LAKE NONA LANDING RETAIL

SUMMARY

<p>Owner Scott Peek Narcoossee Land Holding Two, LLC</p> <p>Applicant Heather Isaacs Tavistock Development Co.</p> <p>Project Planner Colandra Jones, AICP</p>	<p>Property Location: The subject property is located west of Andric Lane, south of Tagore Place, and north of Vickrey Place (±18.01 acres, District 1).</p> <p>Applicant's Request:</p> <ol style="list-style-type: none"> 1. Specific Parcel Master Plan (SPMP) approval for 121,100 square foot big box retail with a 37,200 square foot garden center on ±12.76 acres within the Education Village PD. 2. Request to redistribute land uses within the Education Village PD. 3. Request for Major Subdivision Plat to create the Preliminary Plat for retail development. 	<p>Staff's Recommendation: Approval subject to the conditions in the staff report.</p>
<p>Updated: March 14, 2016</p>

EDUCATION VILLAGE PD DEVELOPMENT PLAN

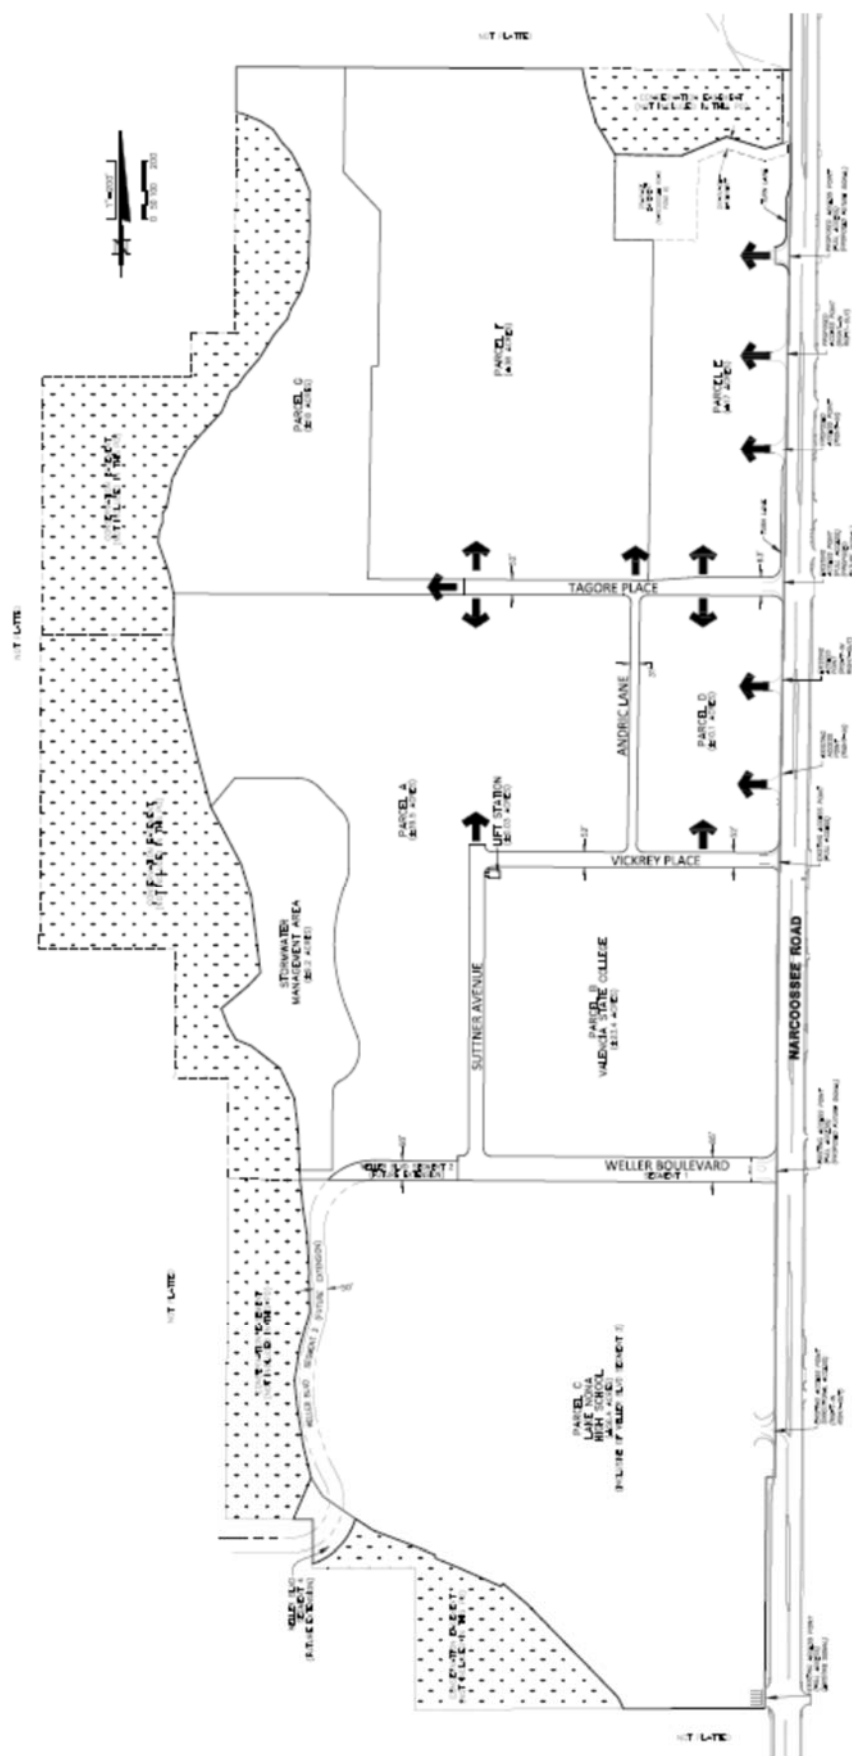
This reconfigured land use plan will result in a residential use (on Parcel G) behind the big box stores (on Parcel F). The plan will also create an unusual shape for the development of multifamily to the south of the subject property (on Parcel A). In order to provide adequate access and circulation for residential uses in these locations, staff may require a north/south connection from Weller Boulevard to Tagore Place as part of a future SPMP application. This could be accomplished using Suttner Avenue, but should not rely on Andric Lane, which is too narrow and would require too many turning movements. The purpose of this connection is to allow residents to travel west toward other portions of Lake Nona without navigating through commercial use areas or out to Narcoossee Road.

PROPOSED BUILDING SIGNAGE

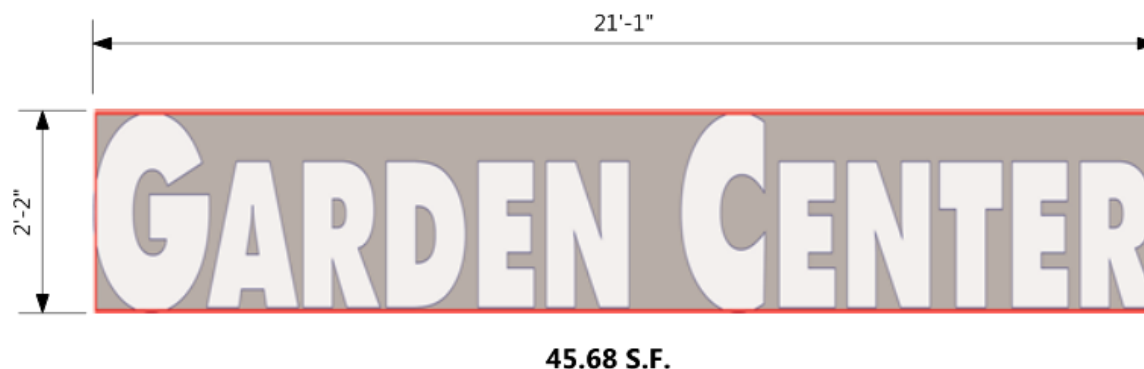
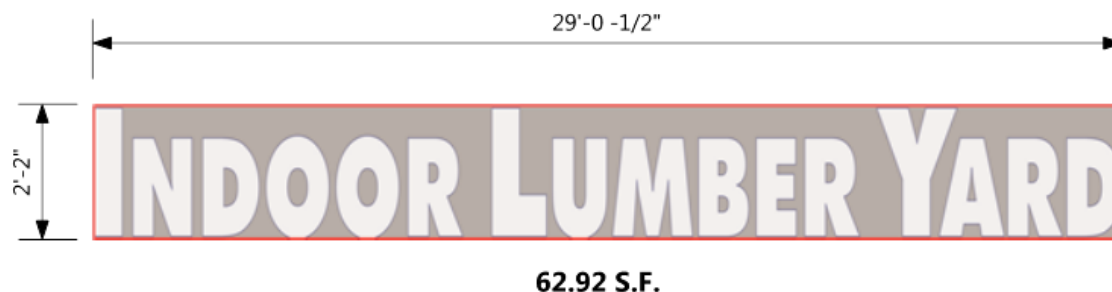
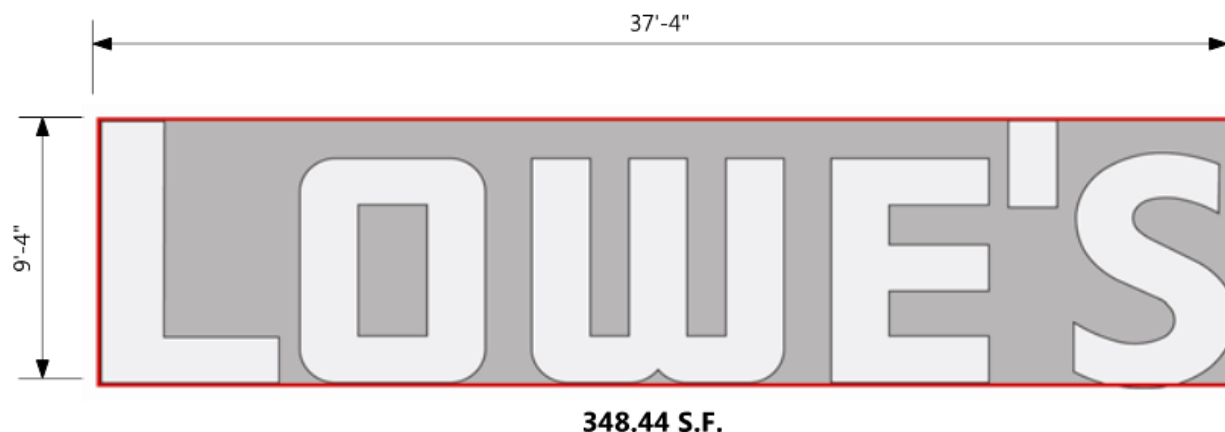
The SPMP proposes a monument sign on the southwest corner of Andric Lane and Tagore Place. This type of signage was approved during the review of the Education Village Master Signage SPMP as a secondary monument sign (Case #MPL2015-00026). This monument sign is 4'-8" in height and has a copy area of 24 square feet. The SPMP also proposes 4 wall signs that totals 502.72 square feet (See graphic below). The signage shall be consistent with Chapter 64 of the LDC.

PROPOSED SITE PLAN

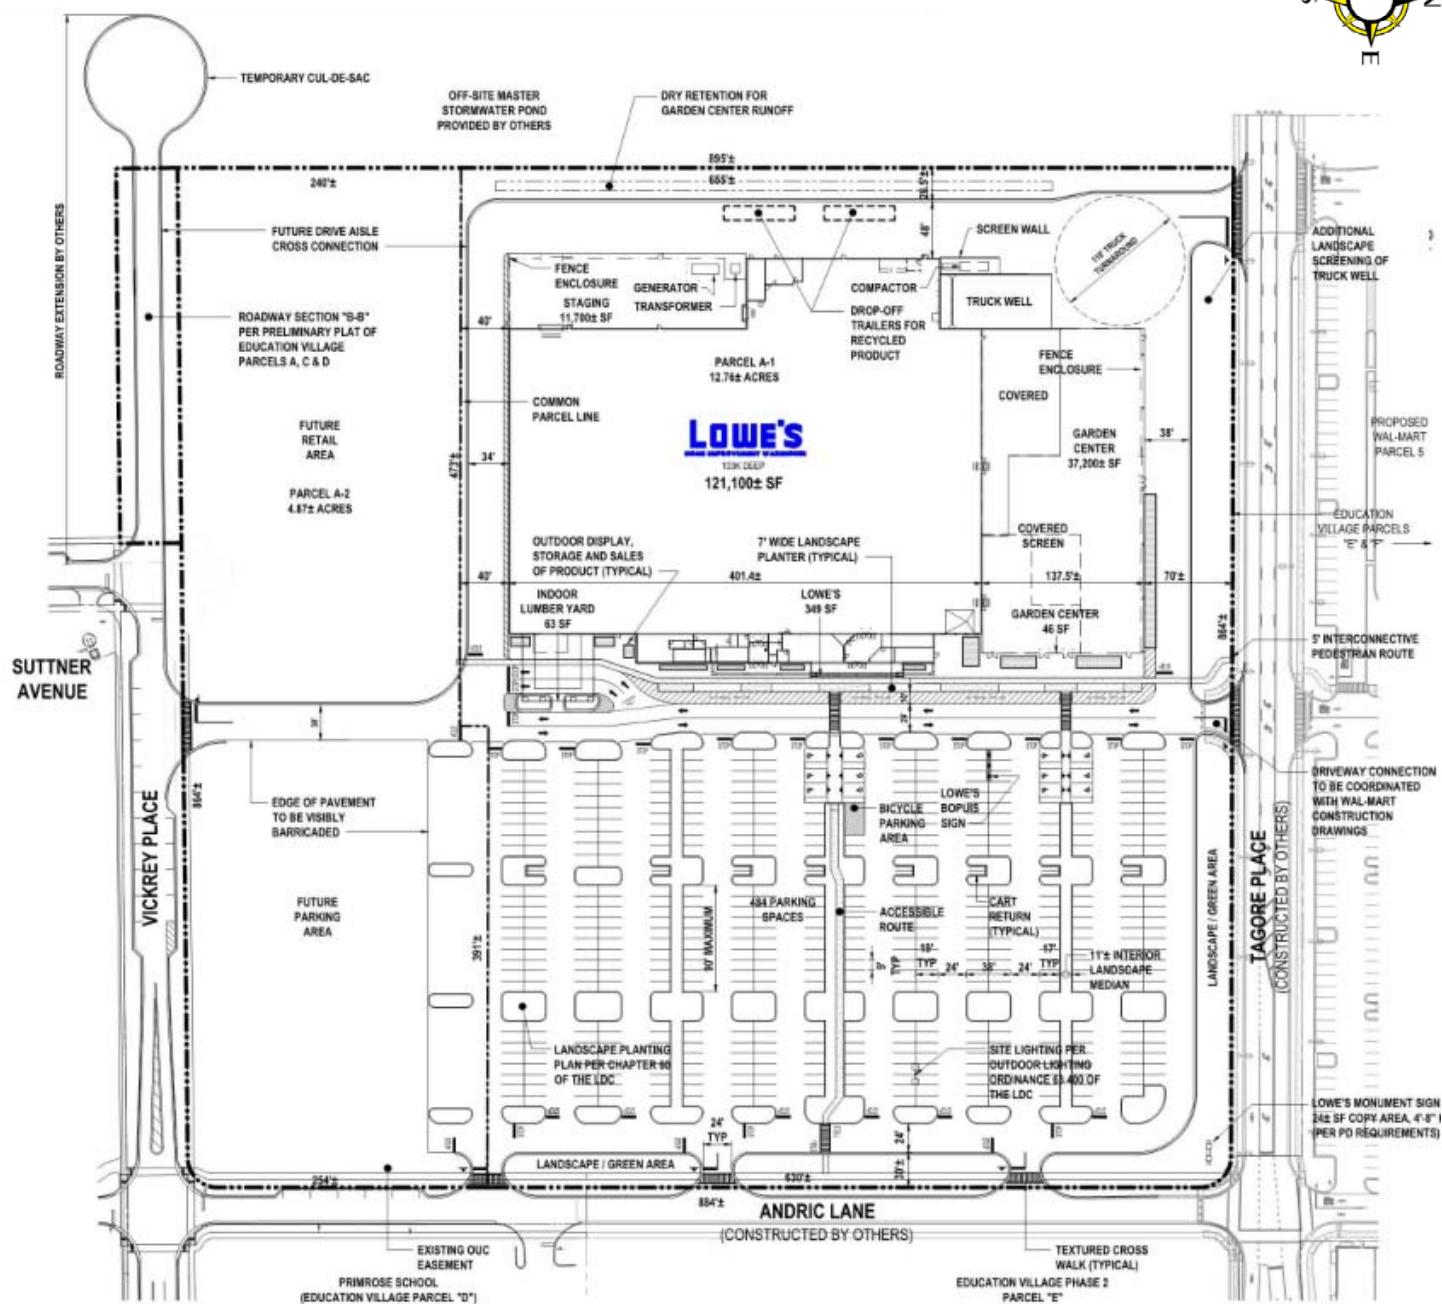
1. The southernmost driveway on Andric Lane is to be removed or relocated to line up with existing driveway to the east. Shift the middle driveway to the north to line up with drive aisle.

3. The southern driveway shall be realigned to avoid any conflicts with Suttner Avenue. Suttner Avenue will eventually extend south to Weller Boulevard and will be the main access point for local traffic to the west that want to avoid Narcoossee Road. The current proposed location would create significant left turn conflicts. Final location to be coordinated with Transportation Engineering and determined during the final engineering permit review. If the driveway is temporary, it shall be removed 5 years after the Certificate of Occupancy for Lowe's.
